**STAFF REPORT**

**RE:** McGregor Plat 1 / LockBox Mini Storage – Preliminary Plat, Final Plat, & Site Plan

**DATE:** March, 14, 2017

**ABOVE:** Proposed development outlined in red dashed line.

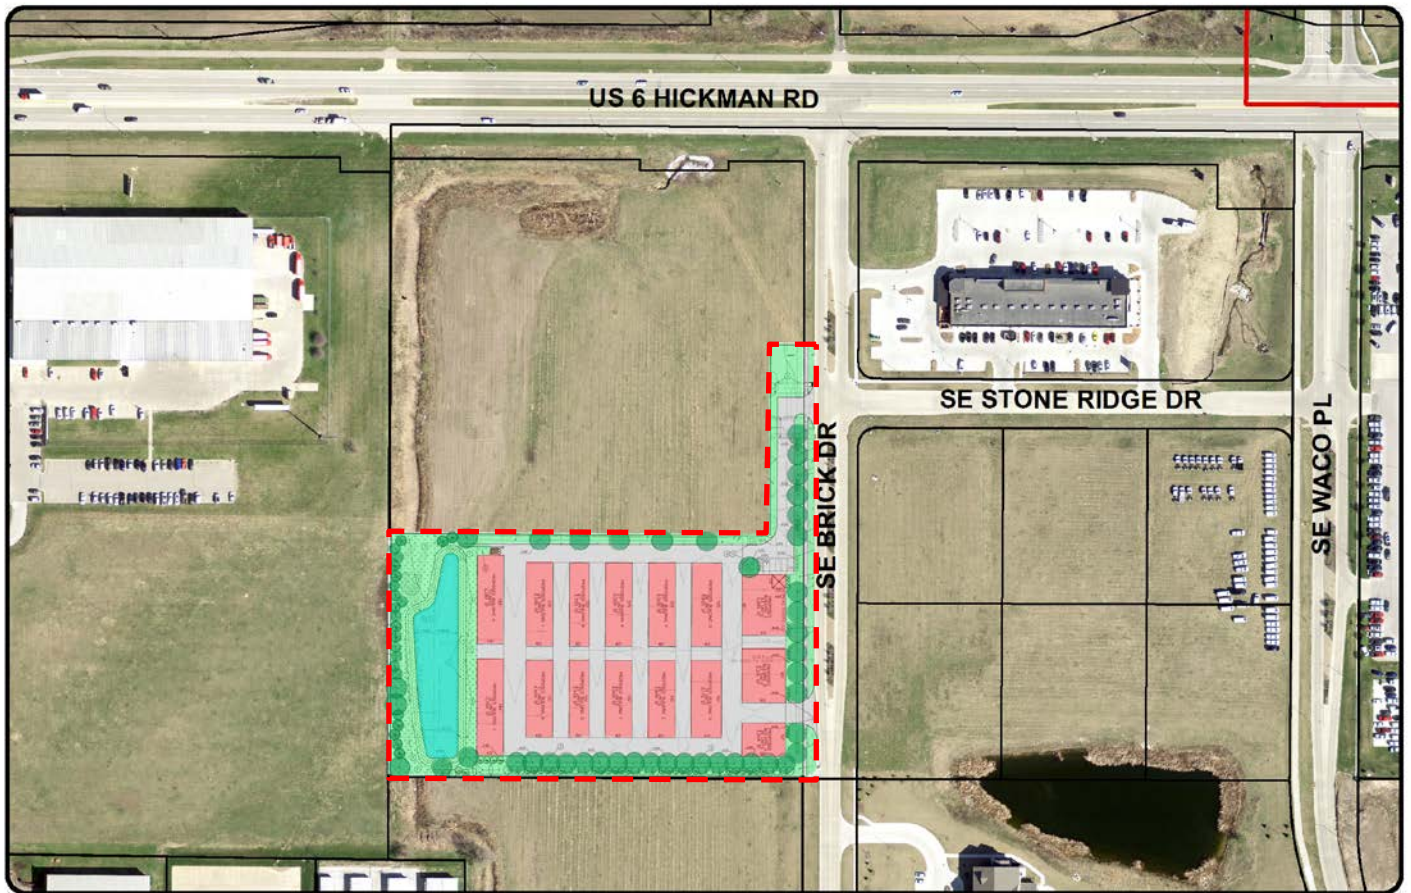
The subject property is located south of Hickman Road and west of SE Brick Drive and is part of the overall Williams Pointe North Planned Development. In 2016, the subject property was rezoned to PD/C-1 to allow for self-storage units to be developed on the property. The applicant requests preliminary plat, final plat, and site plan approval for a self-storage development on the proposed 5.38 acre lot.
